**CITY PLAN COMMISSION****THURSDAY, AUGUST 8, 2024****FILE NUMBER:** S234-161**SENIOR PLANNER:** Hema Sharma**LOCATION:** Easter Avenue, south of Fordham Road**DATE FILED:** July 11, 2024**ZONING:** R-7.5(A)**CITY COUNCIL DISTRICT:** 4**SIZE OF REQUEST:** 0.780-acres**APPLICANT/OWNER:** Eduardo Salinas Martinez

**REQUEST:** An application to replat a 0.780-acre tract of land containing all of Lot 2A in City Block 3/5018 to create a 3-lot shared access development with 7,500 square feet lot each and one Common Area on property located on Easter Avenue, south of Fordham Road.

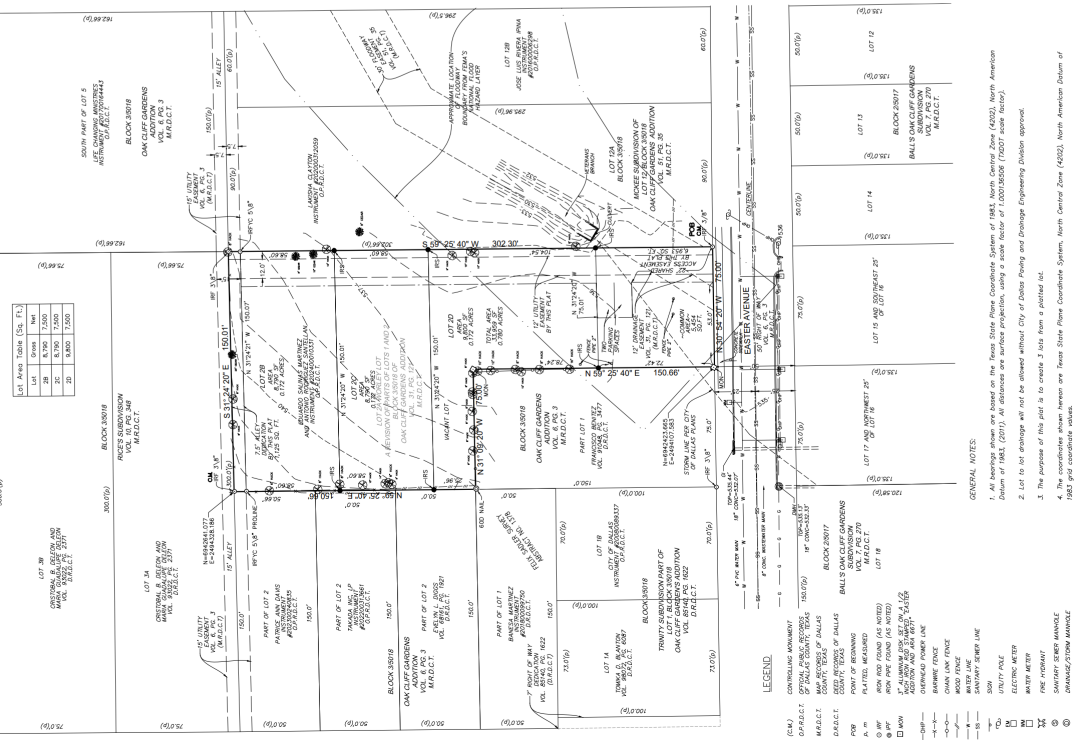
12. Submit a full set of Civil Engineering Plans (drainage, paving, street signage/markings/lighting) prepared per City Standards by a licensed (TX) Professional Engineer to Engineering Division in Room 200, Oak Cliff Municipal Center (i.e. 311T/DP). Additions and alterations to the public infrastructure require approval and may require private development contracts with bonds. 51A-8.102 (c); 8.601(b)(4),(5),(6),(7),(8),(9)
13. Detention may be required if the capacity of available outfall is not adequate to carry the developed runoff. Section 51A-8.611(c).
14. Place a note on the final plat stating "Lot-to-Lot drainage will not be allowed without proper City of Dallas Engineering Division approval" 51A 8.611(e)
15. Existing drainage conveyance within the property is required to be sized in compliance with Section 51A-8.611(a)(1) of the City of Dallas Code.

16. On the final plat, determine the 100-year water surface elevation across this addition.
17. On the final plat, dedicate floodway easement, floodway management area or floodway easement (within common area), with the appropriate easement statement included on the face of the Plat. 51A 8.611(d); DWU Floodplain Management; Drainage Design Manual Addendum V

18. On the final plat, include additional paragraph in Owner's Certificate (pertaining to the floodplain). 51A 8.611(d); DWU Floodplain Management; Drainage Design Manual Addendum V

19. On the final plat, specify minimum fill and minimum finished floor elevations. *Section 51A-8.611(d), Trinity Watershed Management.*
20. On the final plat, show the natural channel set back from the crest of the natural channel. *Section 51A-8.611(d), Trinity Watershed Management.*

23. Prior to final plat, submit a completed final plat checklist and all supporting documents.
24. On the final plat, all access easement(s) must be recorded by separate instrument(s) and the recording information must be shown on the final plat. *Platting Guidelines.*
25. On the final plat, show recording information on all existing easements within 150 feet of the property.
26. On the final plat, show all additions or tracts of land within 150 feet of the property with recording information. *Platting Guidelines.*
27. On the final plat, chose a new or different addition name. *Platting Guidelines.*
28. On the final plat, add 3-foot barrier easements @ alley dedication.
29. On the final plat, add new drainage easement for storm drain @ south end of property.

30. Provide additional shared access area easement, up to 26 feet, for compliance to Dallas Fire Code when building height is 30 feet or greater.
31. A water and wastewater easement at least 12 feet wide to be used exclusively for public water and wastewater below grade must be provided within the Shared Access Area Easement & labeled on the plat. *Section 51A-4.411(d)(2) and*

32. No building permit may be issued to authorize work in the Shared Access Area Development until the final plat and the Shared Access Area Agreement have been recorded in the real property records of Dallas County, and the recording information has been placed on the face of the plat, and all other requirements of the Shared Access Area development have been met. Section 51A-4.411(c)(3)

37. Include the words "Shared Access Development" in the title block of the final plat. Platting Guidelines
38. Place a note on the final plat stating: "No vehicular access is permitted to adjacent property outside the platted property from the shared access area except to a public or City Council approved Private Street." Section 51A-4.411(d)(3), and 51A-4.411(d)(10)

39. If a guard house is provided, it must be at least 30 feet from the shared access point. Section 51A-4.411(d)(8)
40. The Shared Access Area Easement must be terminated a minimum of 3 feet from the adjacent property or right-of-way. Section 51A-8.618(b)

46. Prior to final plat, Contact the Addressing for help determining an acceptable name for the new shared access drive/easement. Section. 51A-8.403. (a) (1) (A) (xiv)". and 51A-8.506. (e)".
47. On the final plat, identify the property as Lots 2B-2D, CA "A" in City Block 3/5018.
